# UNITED STATES PATENT AND TRADEMARK OFFICE

APPLICATION NO.	FILING DATE	FIRST NAMED INVENTOR	ATTORNEY DOCKET NO.	CONFIRMATION NO.
10/768,150	02/02/2004	John B. Permenter	24024.00	6427

<b>Office Action Summary</b>	Application No.	Applicant(s)	
	10/768,150	PERMENTER, JOHN B.	
	Examiner	Art Unit	
	Charles E. Phillips	3751

*Fig. 2*

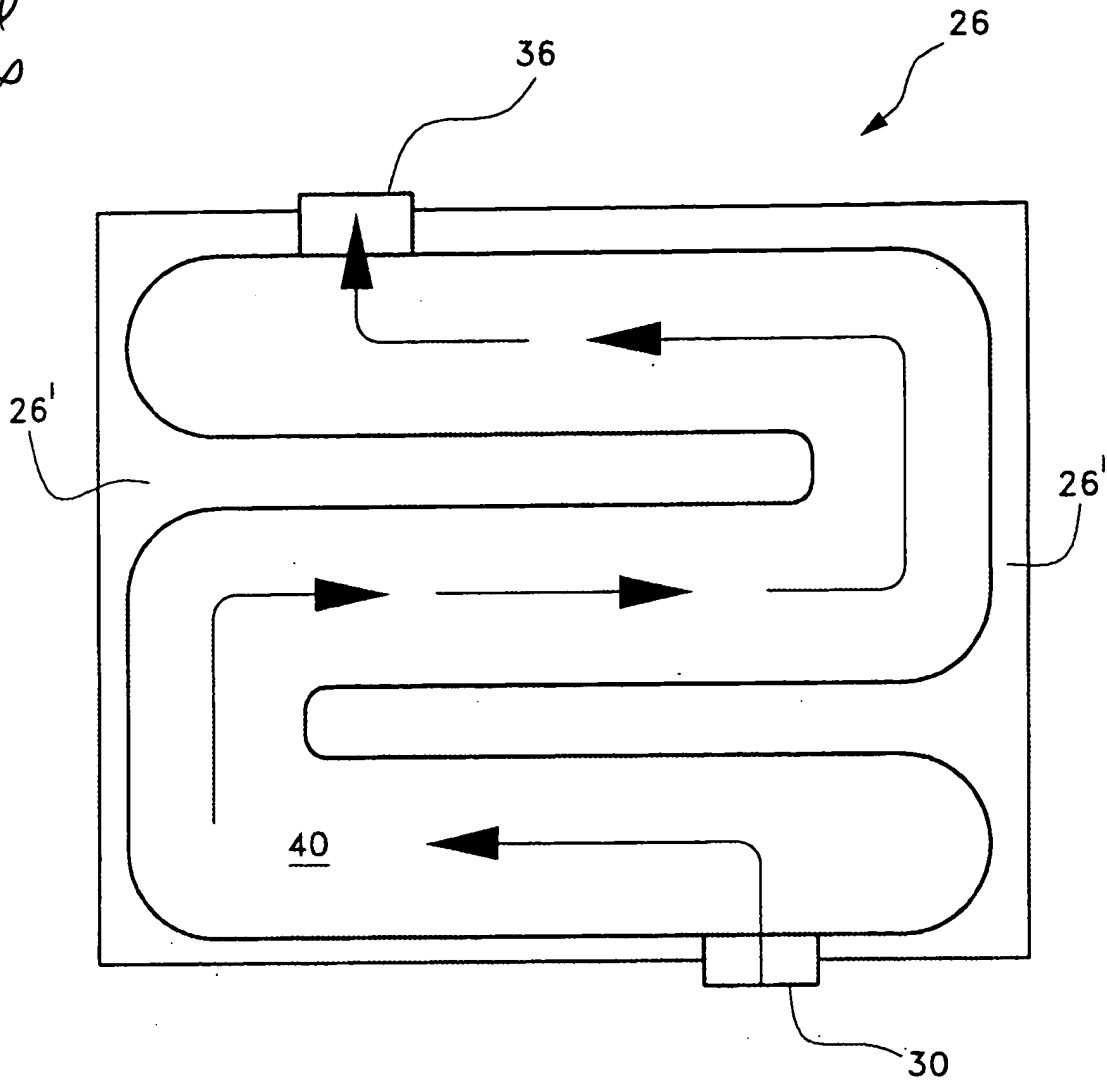
The drawing changes to Fig. 2 are approved. Applicant is required to cancel the new matter in the reply to this Office Action.
